ADDENDUM No. 1

BID #5795

NORTH COLLEGE AVENUE AND JEFFERSON/RIVERSIDE AVENUE IMPROVEMENTS

CONCRETE STORM DRAIN BEDDING

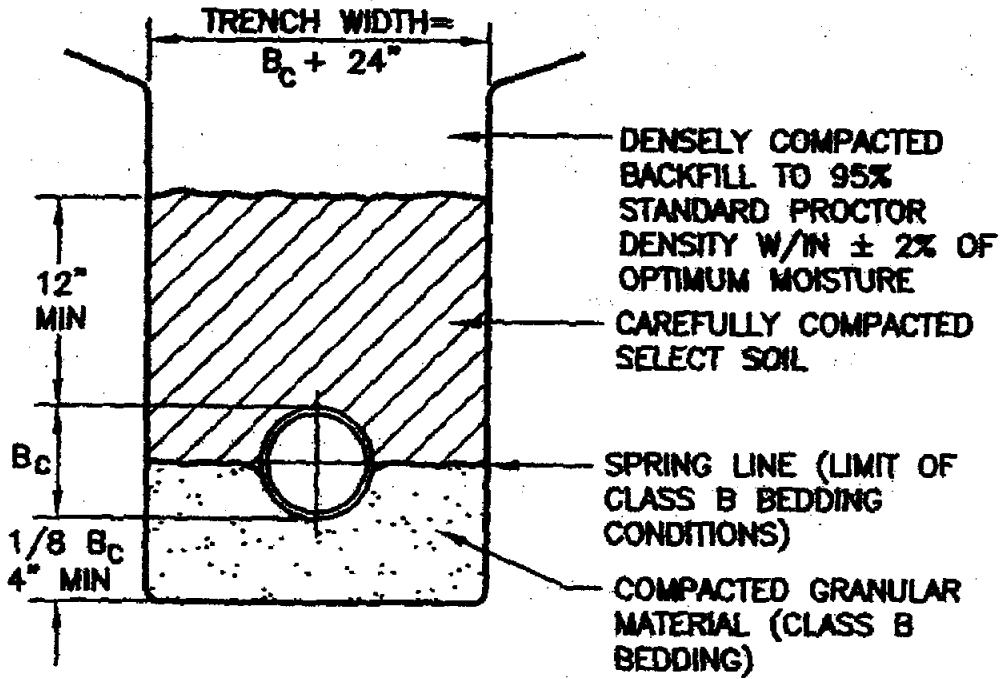
ITEM 8: Clarification of Reinforced Concrete Pipe Installation Detail

The following detail shall apply to the installation of all RCP Storm Drain pipe.

CONCRETE STORM DRAIN BEDDING
NTS

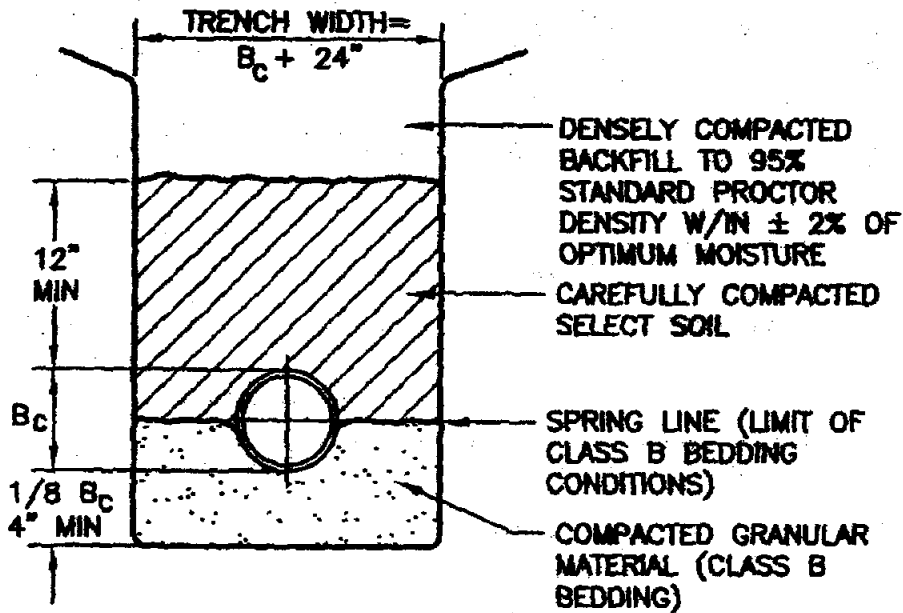
ITEM 8: Clarification of Reinforced Concrete Pipe Installation Detail

The following detail shall apply to the installation of all RCP Storm Drain pipe.
